SUBJECT: LASALLE COUNTY STATION, UNITS 1 AND 2 - ENVIRONMENTAL
ASSESSMENT AND FINDING OF NO SIGNIFICANT IMPACT RELATED TO
REQUEST FOR LICENSE AMENDMENTS TO TECHNICAL
SPECIFICATION 3.7.3, "ULTIMATE HEAT SINK" (EPID L-2020-LLA-0165)

ENCLOSURE
FEDERAL REGISTER NOTICE
ENVIRONMENTAL ASSESSMENT

ACTION: Environmental assessment and finding of no significant impact; issuance.

Figure 1. Current and Proposed Temperature of Cooling Water Supplied to the Plant from the CSCS Pond Versus Time of Day Requirements

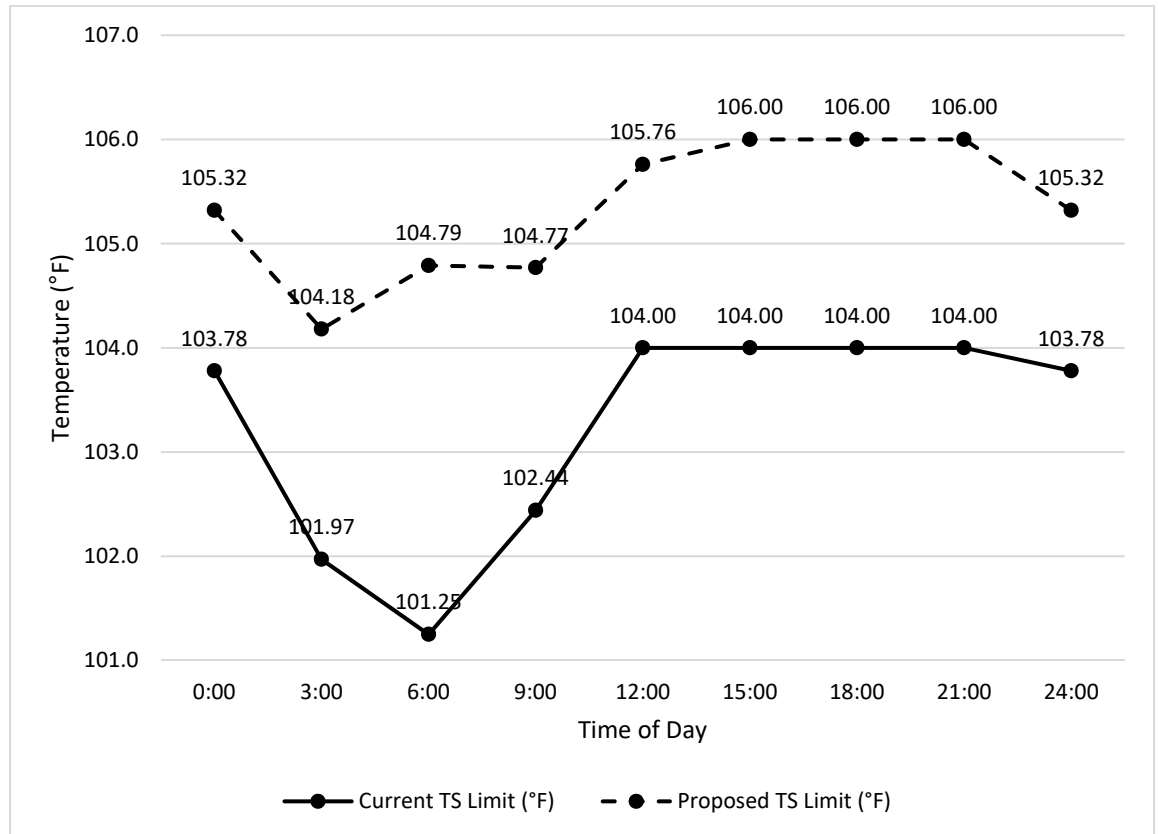
The proposed action would also modify the temperature curve associated with TS SR 3.7.3.1. This requirement currently states, "Verify cooling water temperature supplied to the plant from the CSCS pond is within the limits of Figure 3.7.3-1." Under the proposed action, Figure 3.7.3-1 would be modified to specify new diurnal temperature limits. The revised TS temperature limits would continue to vary with the diurnal cycle and would continue to limit the maximum temperature of the UHS supplied to plant safety systems to below 107 degrees Fahrenheit ($^{\circ}$ F) (41.7 degrees Celsius ($^{\circ}$ C)), the design limit of the plant. The revised limits would increase the allowable maximum UHS temperature of cooling water by 1.54 to 3.54 $^{\circ}$ F (0.85 to 1.97 $^{\circ}$ C) as compared to current limits and depending on time of day. Table 1 lists the current and proposed temperature limits, and Figure 1 depicts these limits graphically.

With regard to potential non-radiological impacts, raising the maximum allowable UHS diurnal temperature limits could cause the UHS portion of the cooling pond to experience increased water temperatures. Because the proposed action would not affect LaSalle's licensed thermal power level, the temperature rise across the condensers as cooling water travels through the cooling system would remain constant. Thus, if water in the UHS were to rise to the proposed allowable limits according to the proposed temperature curve, heated water returning to the cooling pond would also

experience a corresponding 1.54 to 3.54 °F (0.85 to 1.97 °C) increase compared to current limits and depending on time of day. That additional heat load would dissipate across some thermal gradient as discharged water mixes within the cooling pond.

The NRC staff anticipates that thermal effects under the proposed action would be qualitatively similar to those described in the FSEIS. The primary difference under the proposed action would be an incremental increase in the likelihood in the summer that fish in the thermally affected portion of the cooling pond would experience thermal effects causally related to plant operation. This is because under the proposed action, Exelon could continue to operate LaSalle during periods of higher UHS temperatures when it would currently be required to shut down. However, because the UHS is a small portion of the cooling pond, the majority of the cooling pond would be unaffected by the proposed action, and fish would be able to seek refuge in those cooler areas. Therefore, only fish within the region of the cooling pond that is thermally affected by LaSalle's
